CONNECTION ASSESSMENT & APPROVAL PROCESS

Project: Midhurst TS: Establish a Second 230kV DESN

CAA ID No. 2003-EX130

Midhurst TS - Establish a 2nd 230/44kV DESN Station

Proposed Expansion of Midhurst TS

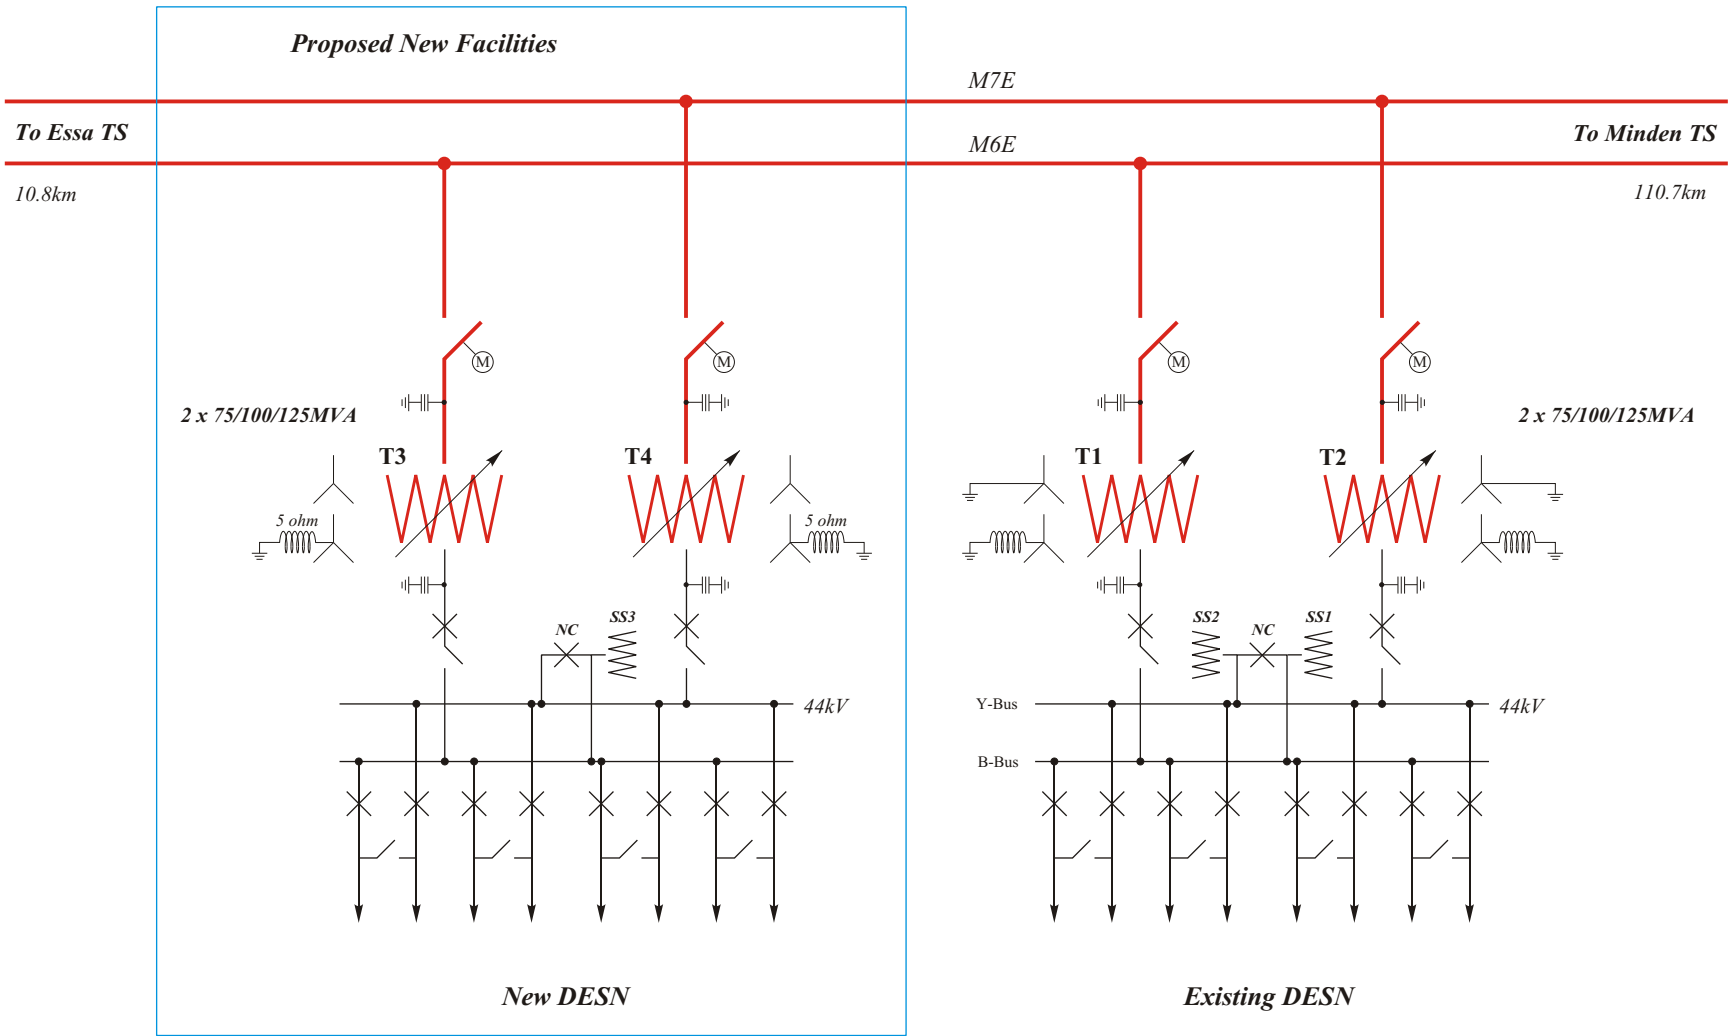
The new DESN Station is to be constructed adjacent to the existing facilities at Midhurst TS and is to be equipped with two step-down transformers, having the same rating as the existing units.

Each transformer is to be connected to the respective 230kV circuit, M6E or M7E, via a motorised disconnect switch. The disconnect switches are to be capable of interrupting the full magnetising current of each transformer.

Diagram 2 provides details of the 44kV busbar arrangement at the new DESN station, with a normally-closed bus-coupler breaker interconnecting the two 44kV busbars. The development is to include eight 44kV feeder positions.

Surge arresters are to be installed on the HV & LV terminals of each step-down transformer.

It is therefore required that provision be included in the plan to develop Midhurst TS for the installation of shunt capacitors.

Load Flow Study Results for the Summer-2006 Peak Condition: Extreme Weather Load Forecast
 With circuit M6E out-of-service

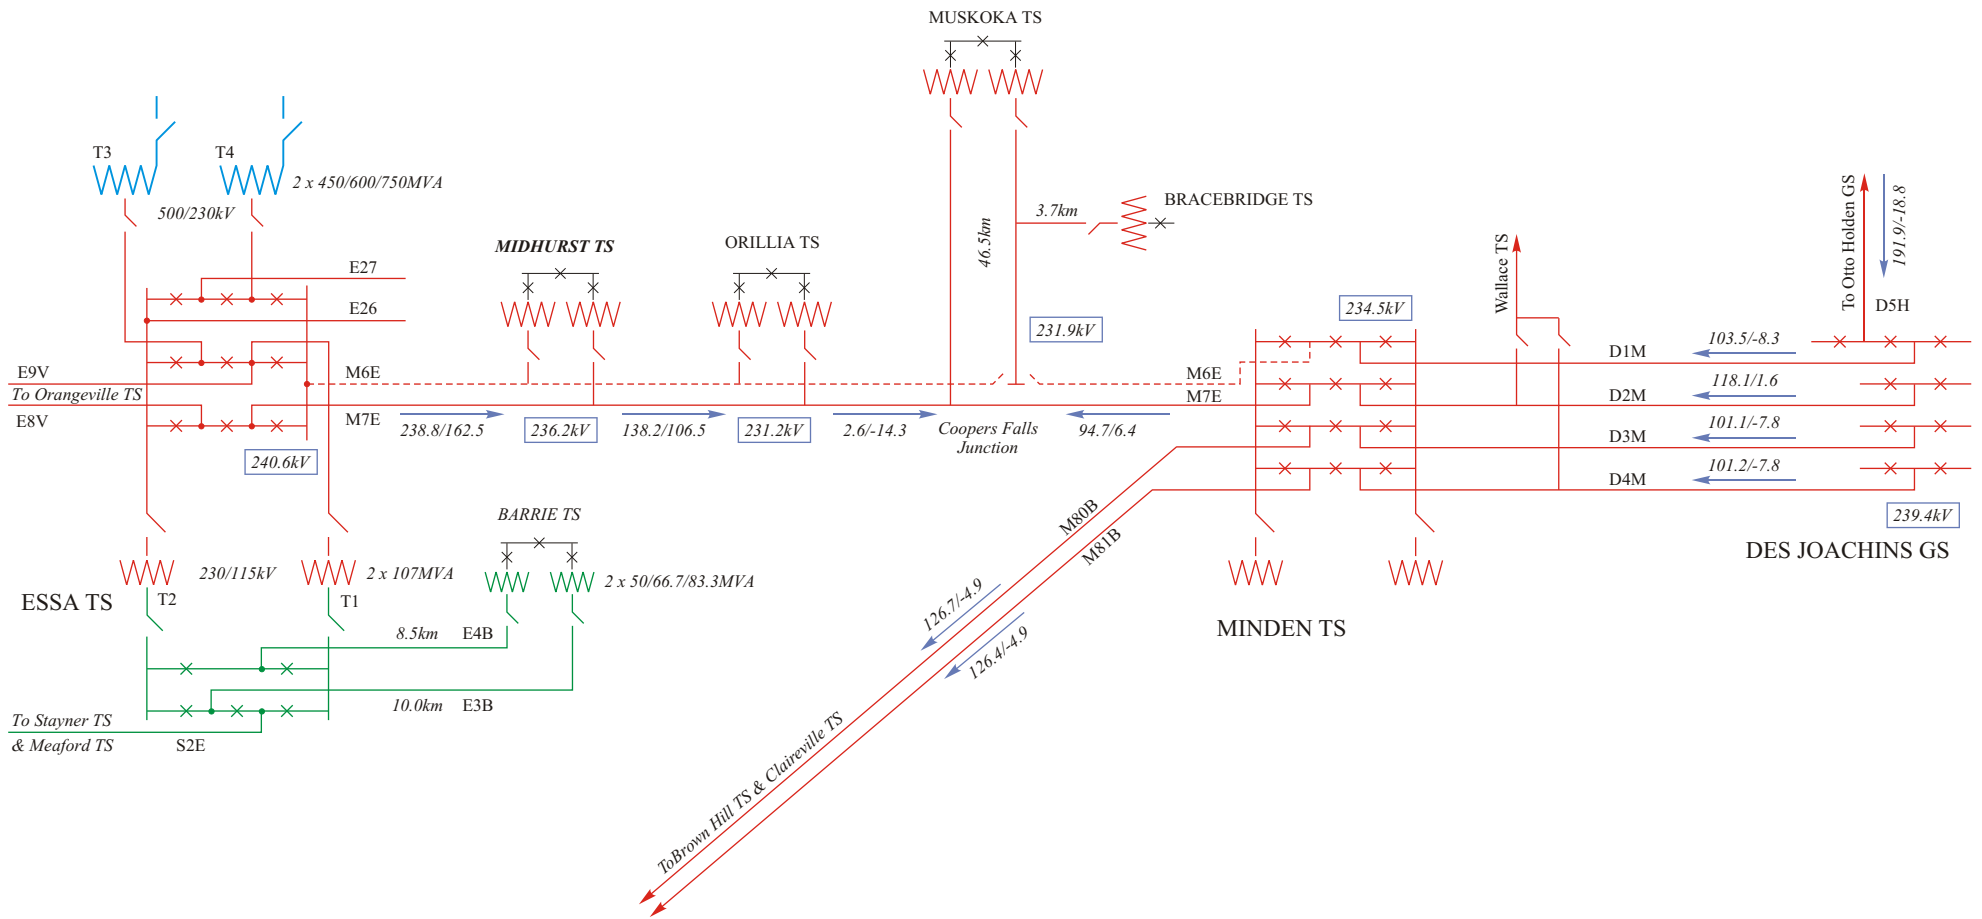
Diagram 4 shows the corresponding flow distribution with the 230kV circuit M6E out-of-service.

This shows that the flow on the companion circuit over the section between Essa TS and Midhurst TS (of ~290MVA) would remain well within the continuous rating of the circuit.

Furthermore, the post-contingency voltages, following tap-changer action, show a decline of less than 3%, which would be within the IMO's criteria.
